Rezoning Transportation Analysis

Petition Number: 2018-111

Revision Log:	Date	Description
	09-20-18	First Review

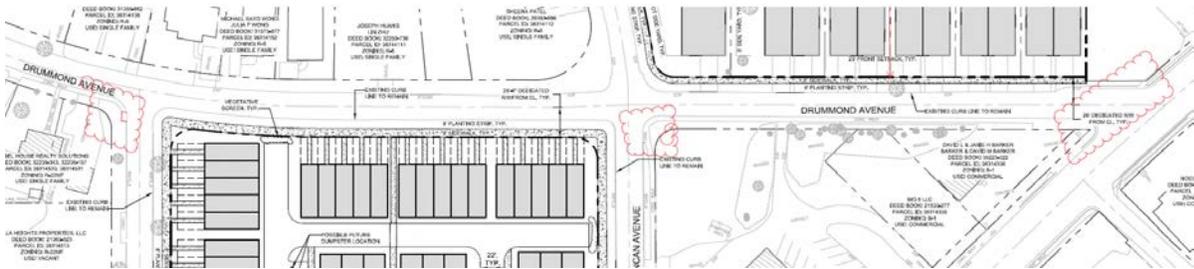
1. **Curbline** The proposed zoning district has a setback measured from back of the existing or proposed future curbline. The location of the future back-of-curb for:
 - a. **Drummond Avenue east of Duncan Avenue:** 14 feet from centerline of the road

- b. **Drummond Avenue west of Duncan Avenue:** existing back-of curb is in the correct future location
 - c. **Duncan Avenue north of Drummond Avenue:** 14 feet from centerline of the road

- d. **Duncan Avenue south of Drummond Avenue:** existing back-of-curb is in the correct future location
 - e. **Lydia Avenue:** Existing back-of-curb is in the correct future location

- f. **Catawba Avenue:** Existing back-of-curb is in the correct future location
2. **Traffic Study** A Traffic Impact Study is not necessary for the complete review of this petition.

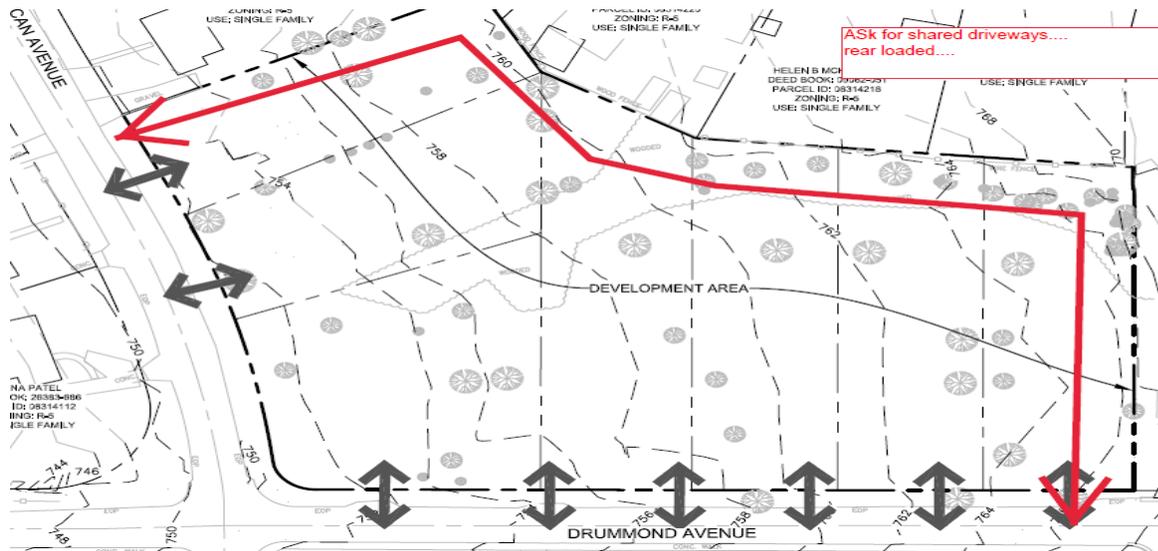
5. The petitioner should revise the site plan and conditional notes to show existing curb ramps and upgraded to meet PROWAG and City standards at the following intersections: Duncan Avenue and Drummond Avenue, Drummond Avenue and Lydia Avenue, The Plaza and Drummond, and Catawba Avenue and Lydia Avenue.
